WSU3 – Replacing Air-Conditioning Compressor Shield Plate (Workshop Campaign)

Vehicle Type: **Panamera 4 E-Hybrid (YAA/YAB)**
Panamera 4S E-Hybrid (YAA/YAB)

Concerns: **Shield plate for air-conditioning compressor**

Air-conditioning compressor shield plate installation position

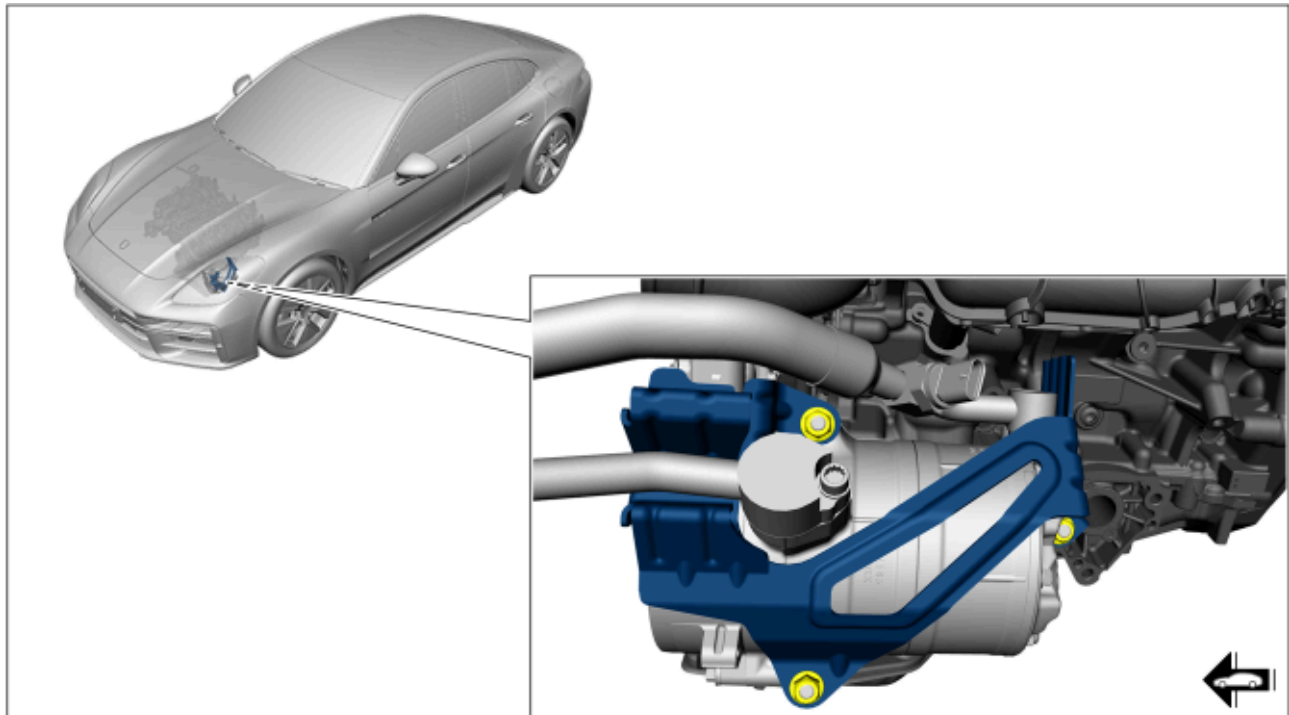
Information: **On the affected vehicles, there is the possibility that a shield plate was installed on the air-conditioning compressor with weld points that do not have the required strength.**
In the event of an impact, the intended protective effect for the refrigerant lines cannot be fully guaranteed by the shield plate.

Action: replacing the air-conditioning compressor shield plate.

- Work Procedure:
- 1 Remove the electric air-conditioning compressor and install it **with the new shield plate**. Note that the low-pressure line on the air-conditioning compressor does not need to be removed from the air-conditioning compressor when replacing the shield plate.
 ⇒ *Workshop Manual '873419A1 Removing and installing electric air-conditioning compressor'*
 - 2 Enter the campaign in the Warranty and Maintenance Logbook.
